V2500-A1/A5 SERIES PROPULSION SYSTEMS SERVICE BULLETIN

This document transmits the Revision 2 to Service Bulletin V2500-ENG-73-0198 and the Revision 2 to the Supplement

V2500-ENG-73-0198

ENGINE FUEL AND CONTROL – FUEL SYSTEM AIR TUBE – INTRODUCTION OF RE-ROUTED BURNER TO
ENGINE ELECTRONIC CONTROLLER (EEC) PRESSURE (PB) SENSE LINE TUBE ASSEMBLIES

Removal of Pb sense line tube assembly
Figure 1

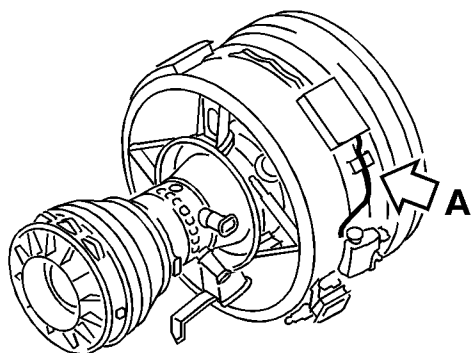
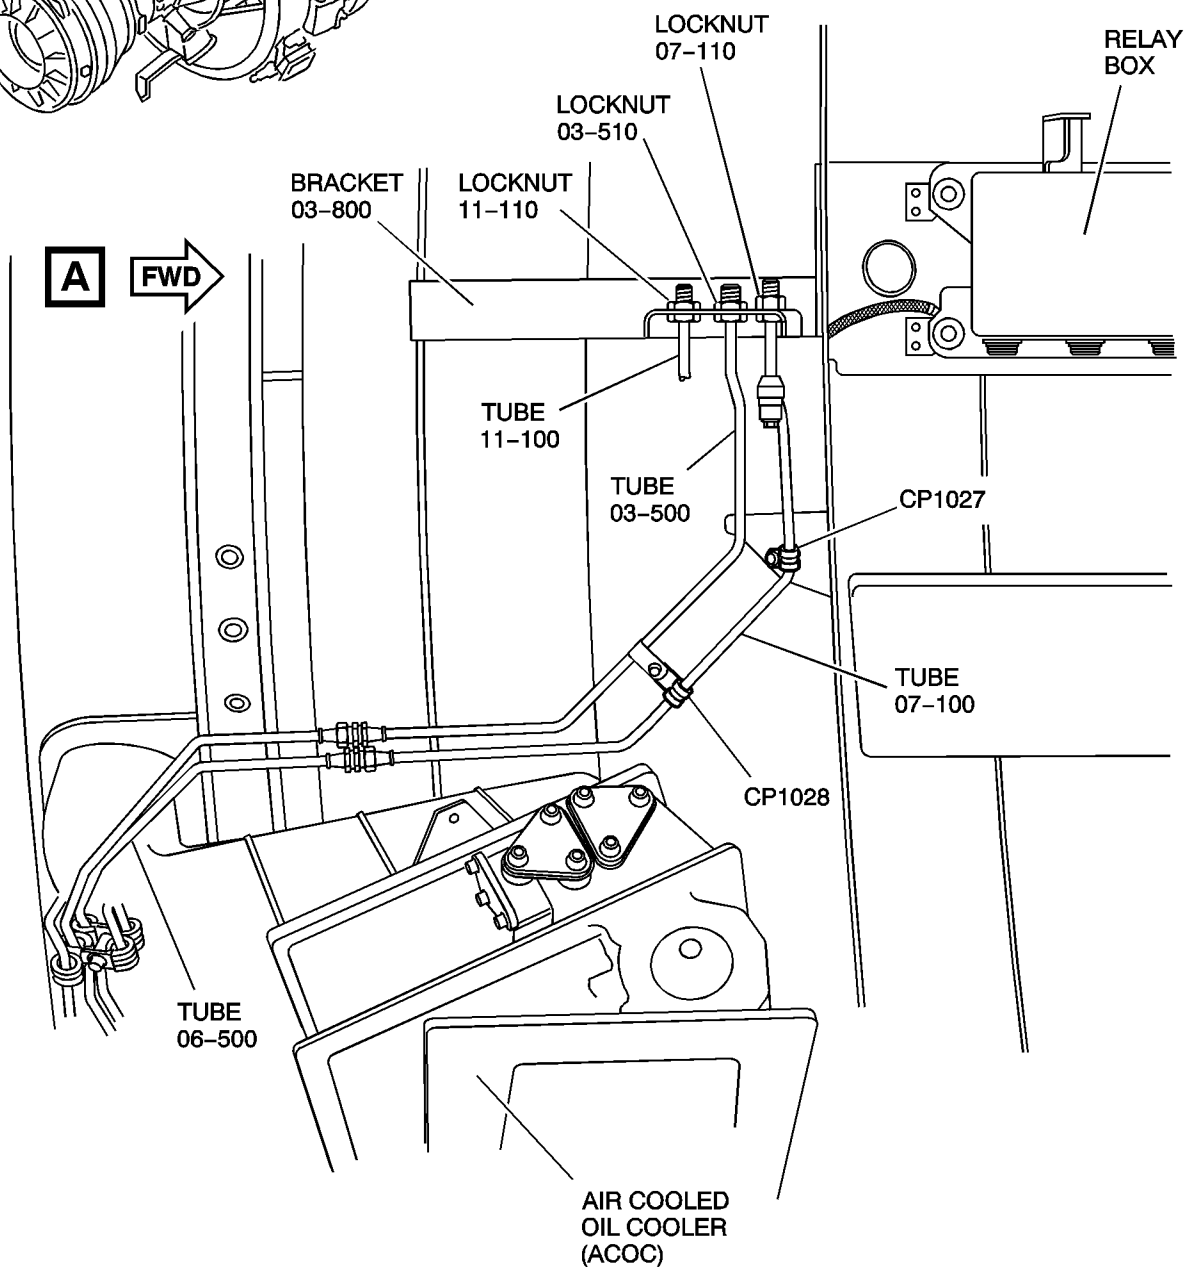
- (a) Remove the Pb sense line flexible tube (73-22-49, 07-500)(Refer to Figure 1)
 - (i) Disconnect the Pb sense line flexible tube (73-22-49, 07-500) from the EEC.

- (ii) Disconnect the Pb sense line flexible tube (73-22-49, 07-500) from the Pb sense line tube assembly (73-22-49, 07-100).
 - (iii) Remove the old Pb sense line flexible tube (73-22-49, 07-500), P/N 44456 from the LP compressor/ intermediate case.

Removal of Pb sense line tube assembly
Figure 2

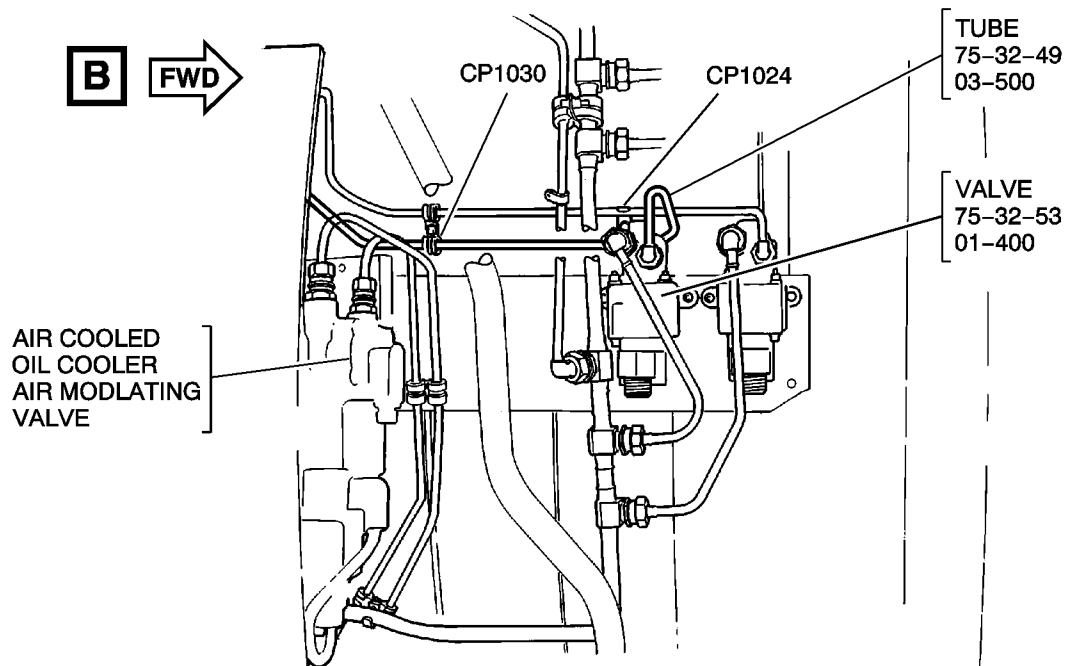
- (b) Remove the Pb sense line tube assembly (73-22-49, 07-100)(Refer to Figure 2)
 - (i) Remove the old locknut (73-22-49, 07-110), P/N MS9201-04 that attaches the Pb sense line tube assembly (73-22-49, 07-100) to the support bracket assembly (73-22-49, 03-800).

(v) Remove the old Pb sense line tube assembly (73-22-49, 07-100), P/N 5A8800 or P/N 6A8091 from the LP compressor/ intermediate case.

Removal of HP compressor stage 10 bleed air control tube assembly
Figure 3

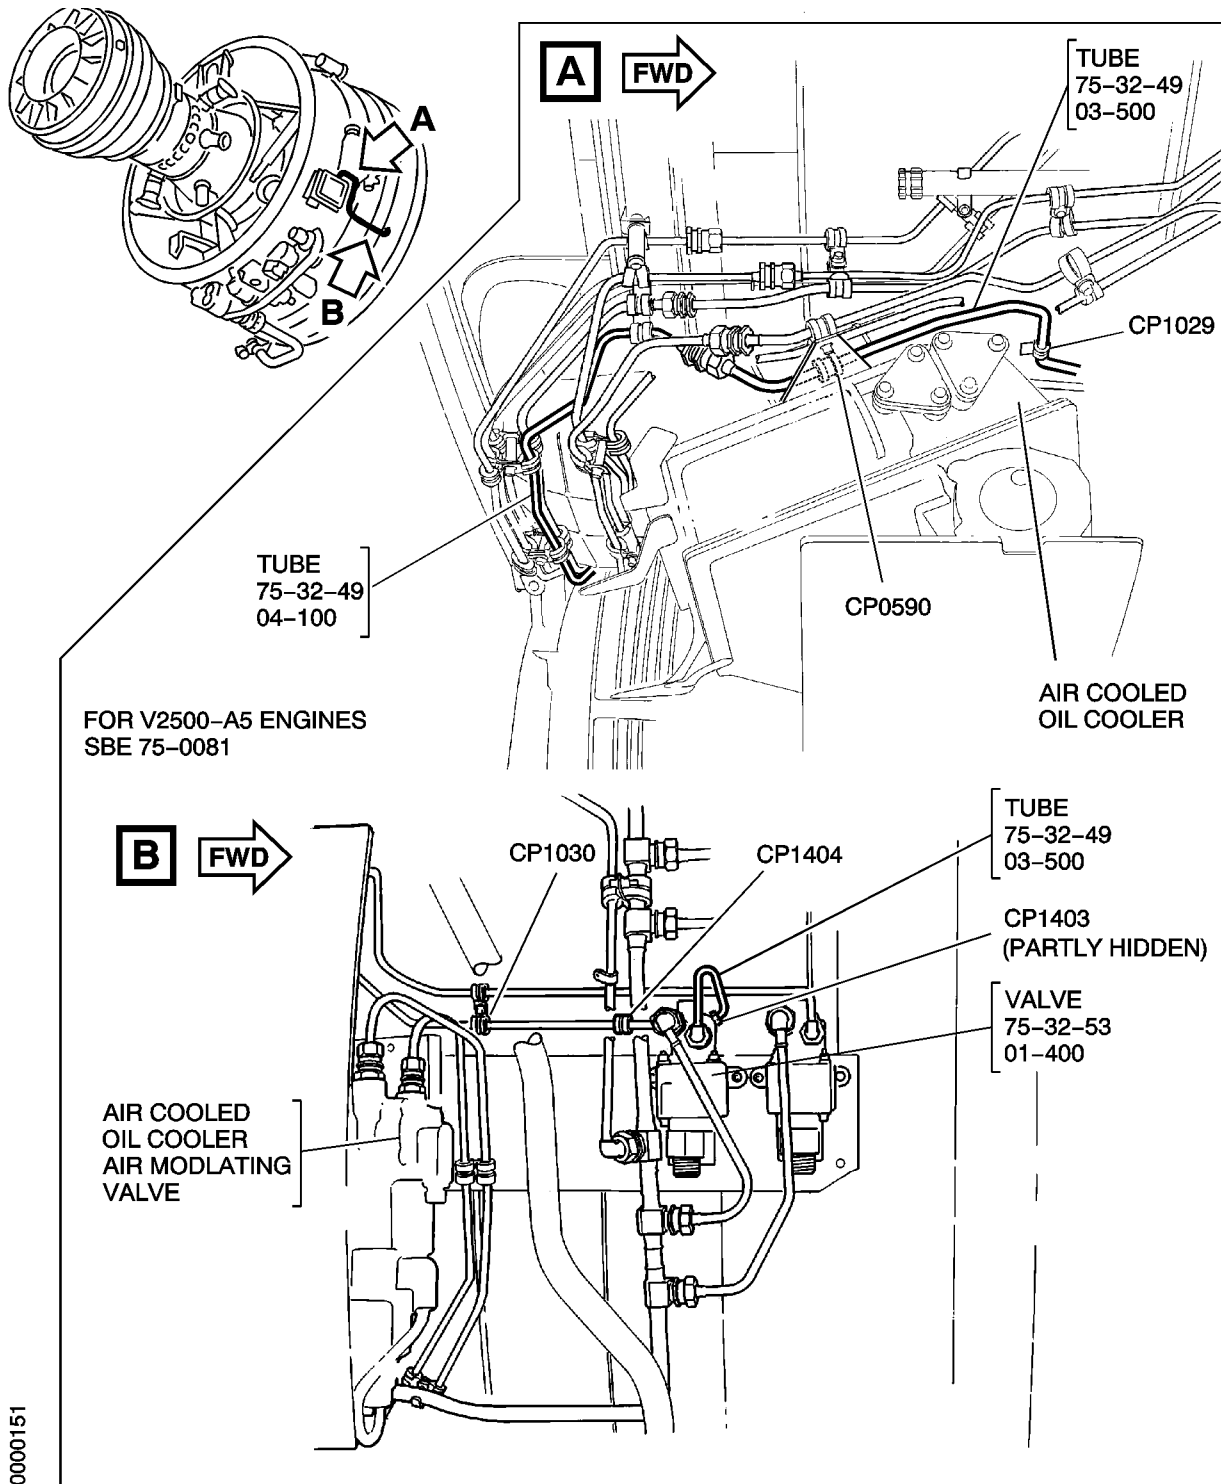
(c) Remove the old HP compressor stage 10 bleed air control tube assembly (75-32-49, 03-500) from the LP compressor/ intermediate case (Refer to Figure 3, 4, 36, 37, 38 and 39)

(7) Remove the old HP compressor stage 10 bleed air control tube assembly (75-32-49, 03-500), P/N 5A9146 from the LP compressor/ intermediate case.

Removal of Pb sense line tube assembly
Figure 9

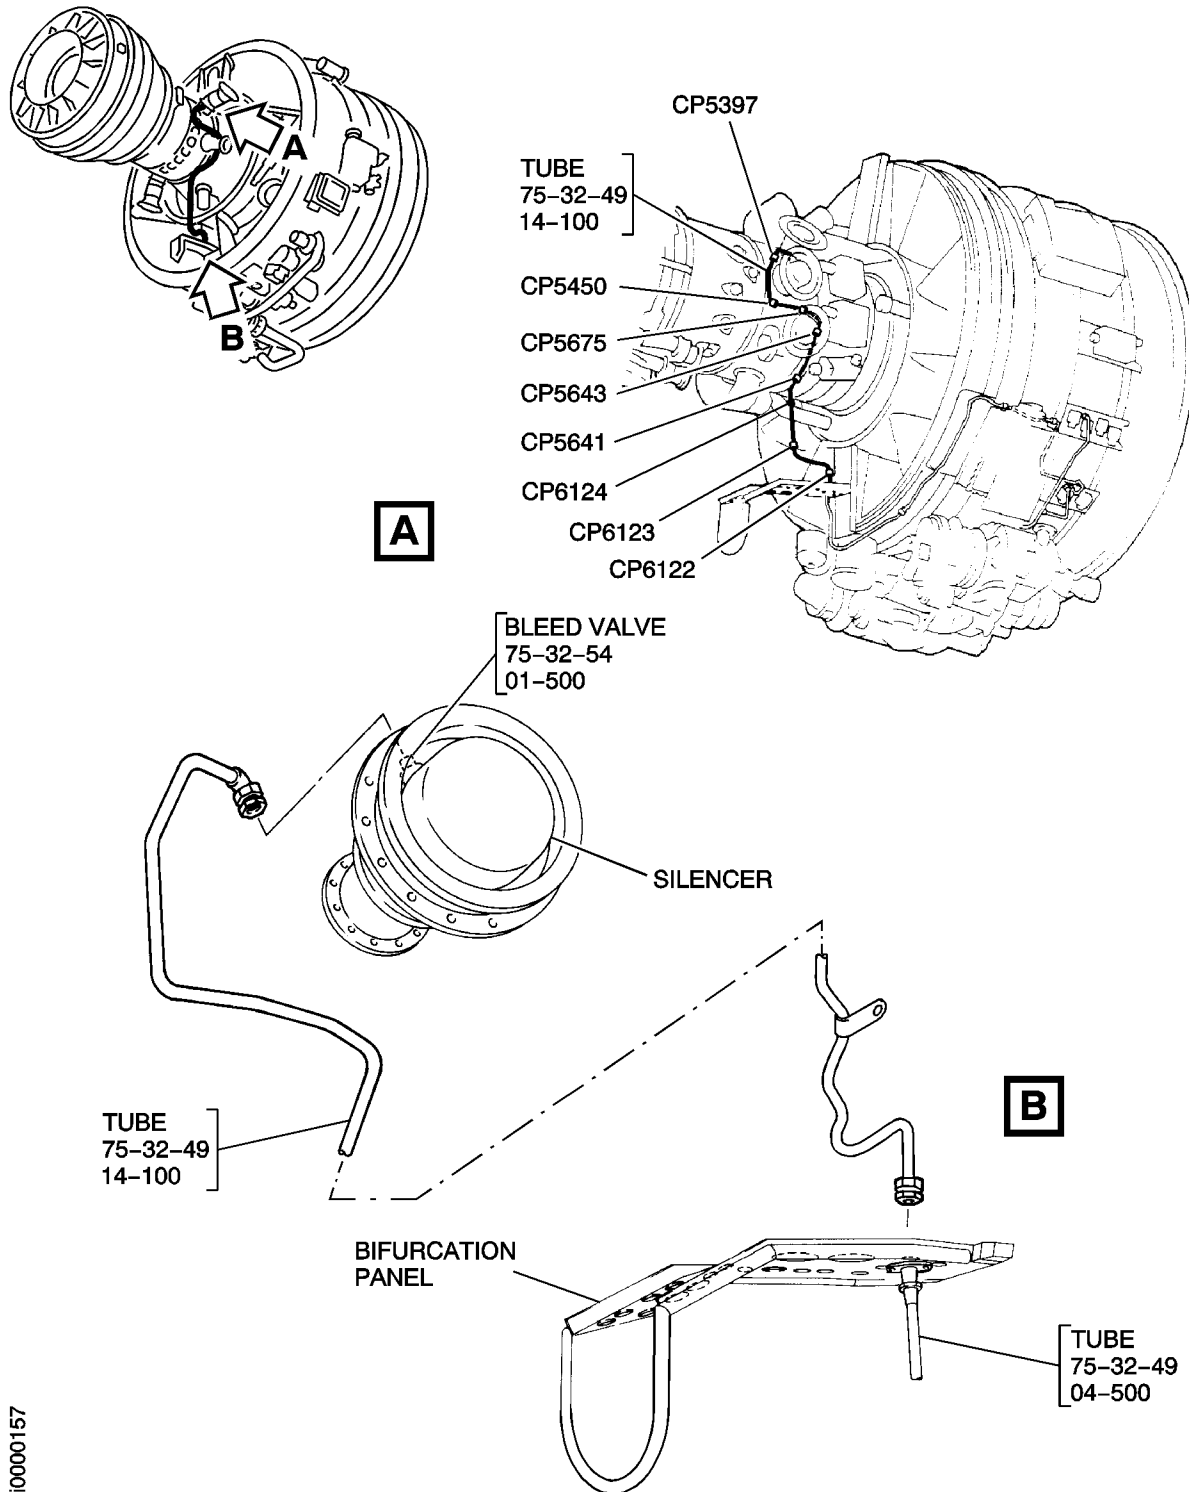
- (e) Remove the Pb sense line tube assembly (73-22-49, 05-500) from the High Pressure (HP) compressor case (Refer to Figure 9, 41, 42 and 43)
- (i) For V2500-A1 Engines:

(8) Remove the old Pb sense line tube assembly (73-22-49, 05-500), P/N 6A6203 from the High Pressure (HP) compressor case.

Installation of Pb sense line tube assembly
Figure 27

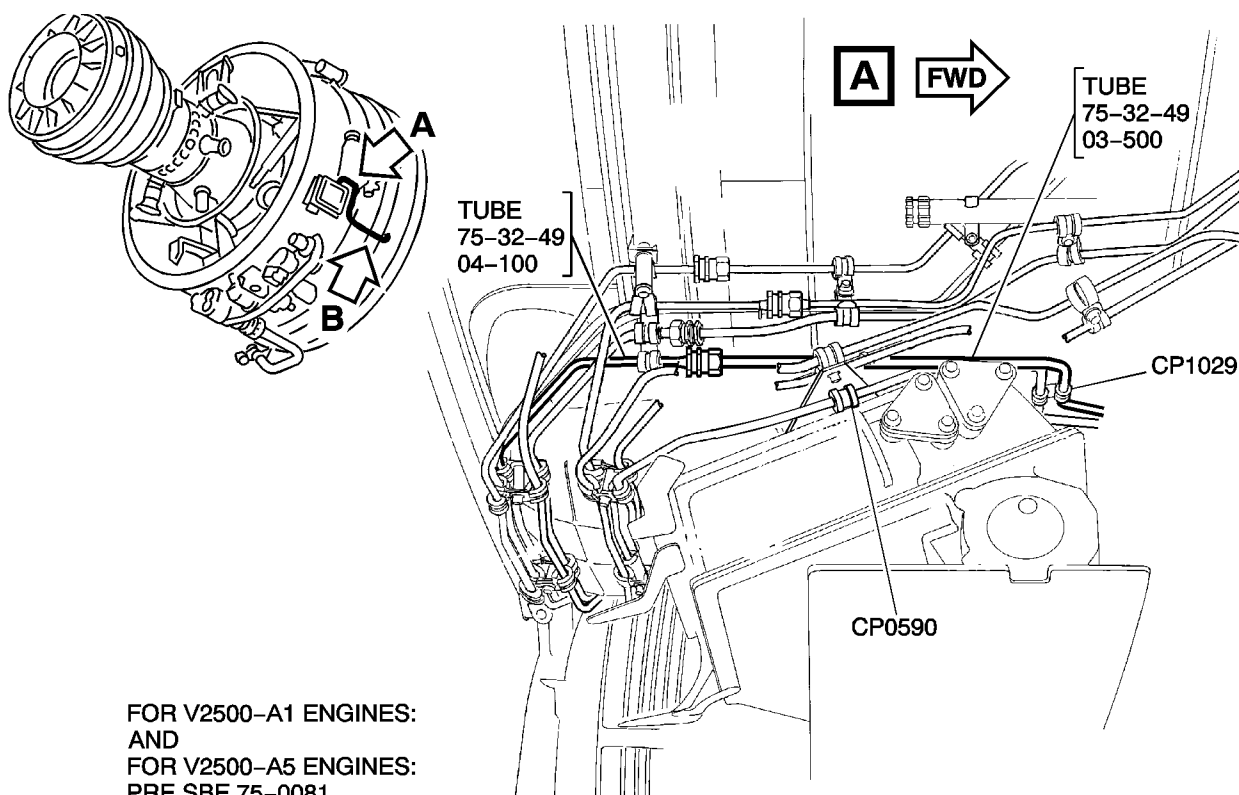
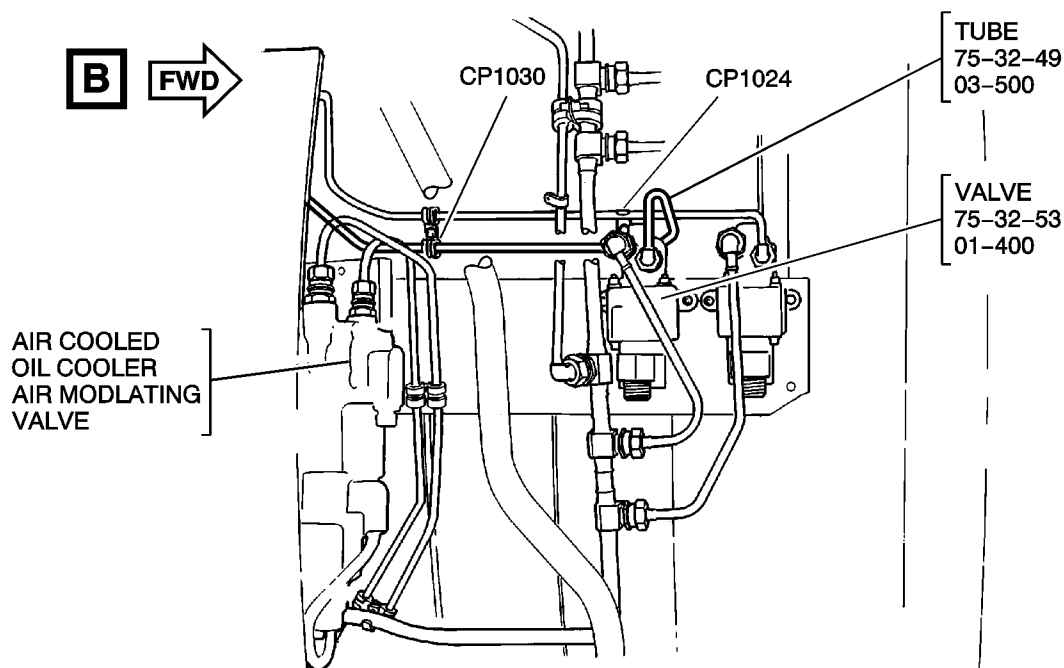
(f) Install the Pb sense line tube assembly (73-22-49, 07-100) to the LP compressor/ intermediate case (Refer to Figure 17, 18, 19, 20, 27 and 30)

- (vi) Torque the coupling nut of the flexible tube (73-22-49, 07-100) to between 142 and 150 lbf in. (16 and 17 Nm).
 - (vii) Torque the coupling nut of the rigid tube (73-22-49, 07-100) to between 159 and 177 lbf in. (18 and 20 Nm).
 - (viii) Safety the coupling nut of tube (73-22-49, 07-100) with safety cable (Material No. V02-274 or V02-275).
 - (ix) Torque the nuts at the clip positions 1482, 1481, 1017 and 0586 to between 36 and 45 lbf in. (4 and 5 Nm).
- (g) Install the revised clip position CP0587 (Refer to Figure 19):

Installation of HP compressor stage 10 bleed air control tube assembly
Figure 28

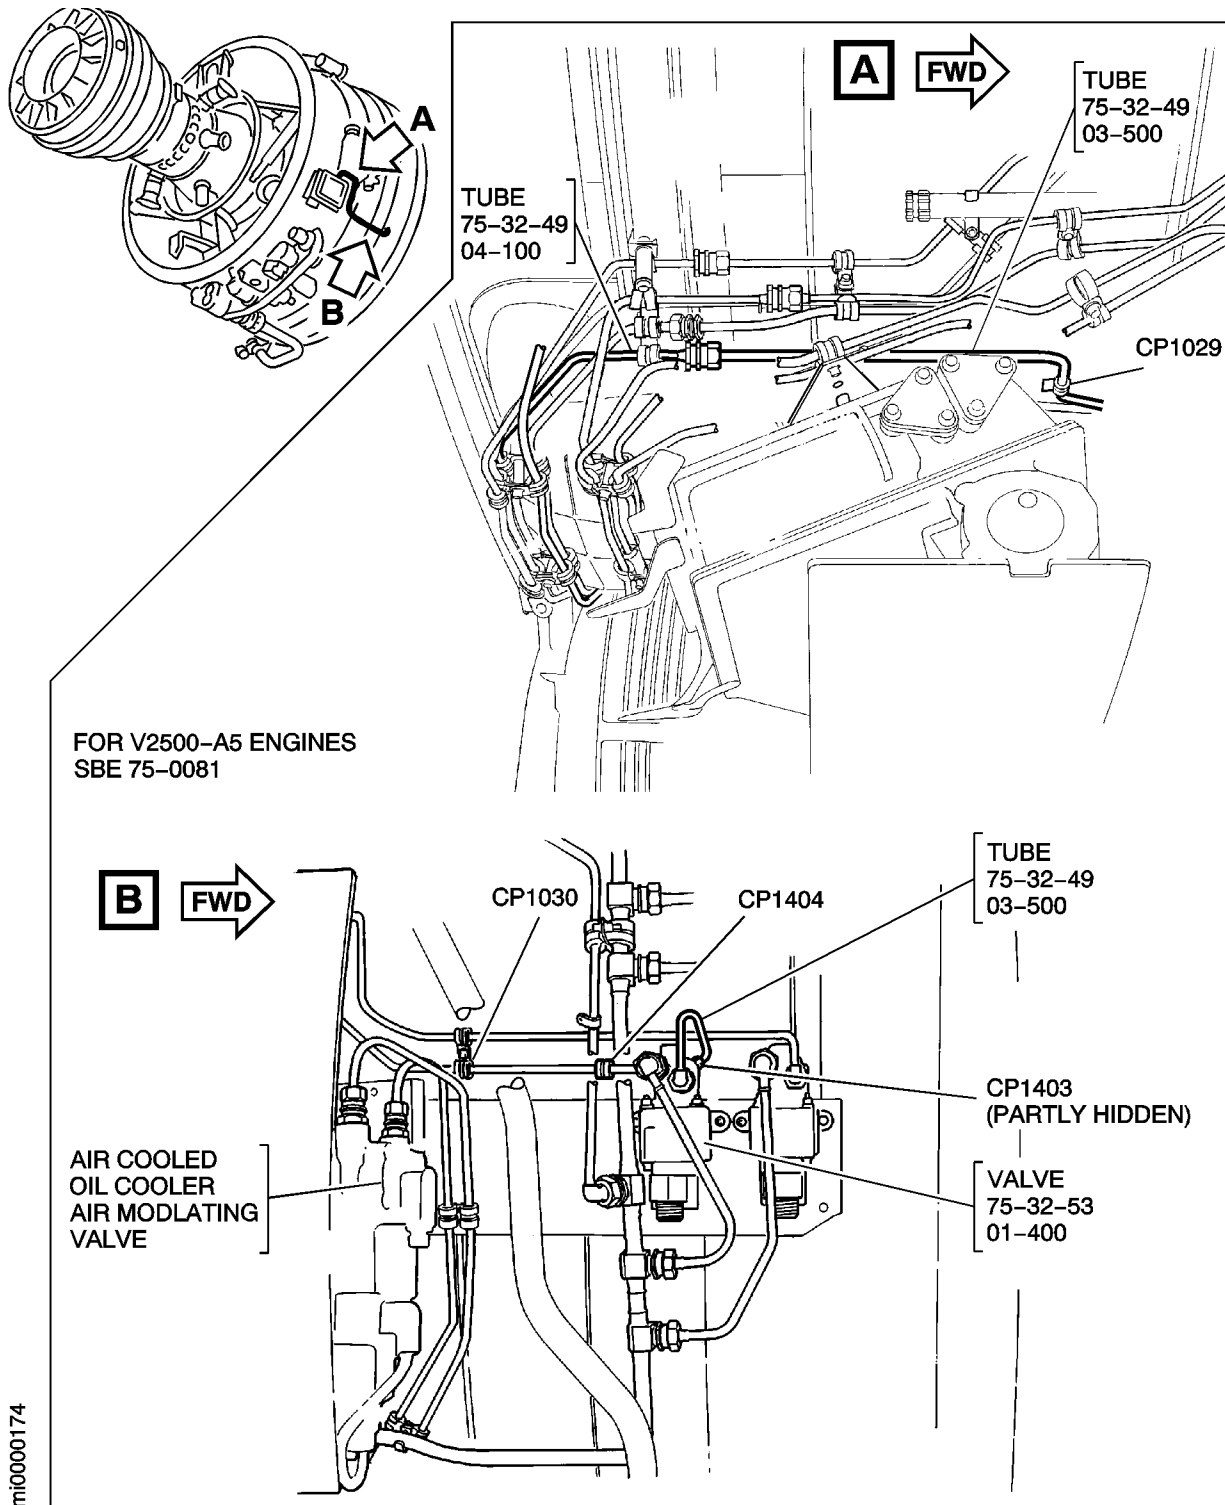
(h) Install the HP compressor stage 10 bleed air control tube assembly (75-32-49, 04-100) to the LP compressor/ intermediate case (Refer to Engine Manual, Chapter 72-00-32 and to step (7)(h)(i) of this Service Bulletin)(Refer to Figure 28 and 29).

Installation of HP compressor stage 10 bleed air control tube assembly
Figure 35

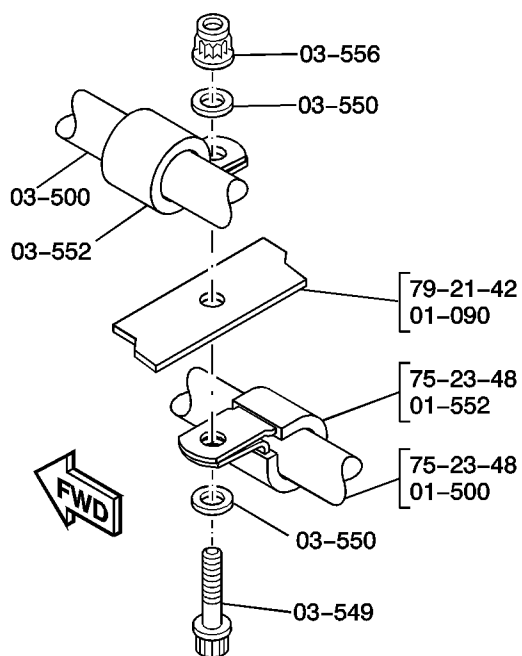
- (c) Install the HP compressor stage 10 bleed air control tube assembly (75-32-49, 14-100) to the HP compressor case (Refer to Engine Manual, Chapter 72-00-40 and to step (7)(c)(i) of this Service Bulletin)(Refer to Figure 35).
